Supplement to

Conversion Instructions for Tempest™ (TM-267, 1st Printing)

This Supplement contains changes to the Major Havoc Conversion Instructions for Tempest. Please make the changes described in this Supplement directly to your instruction manual.

The following changes affect Figure 17-Deflection PCB Schematic (Version 4).

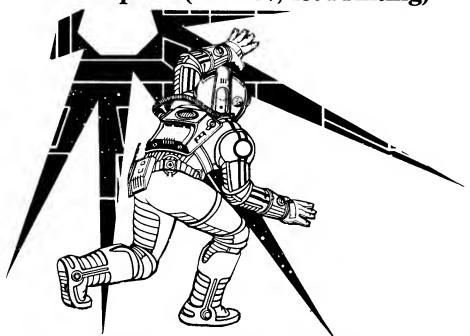
Page 4	i3. Delete the two	1N4002 diodes from	transistors O102 and O10	13
-		Delote the two	II I I I I I I I I I I I I I I I I I I		ı

☐ **Page 43.** Add two 1N4002 diodes between the emitter and collector of transistors Q705 and Q706 as follows:
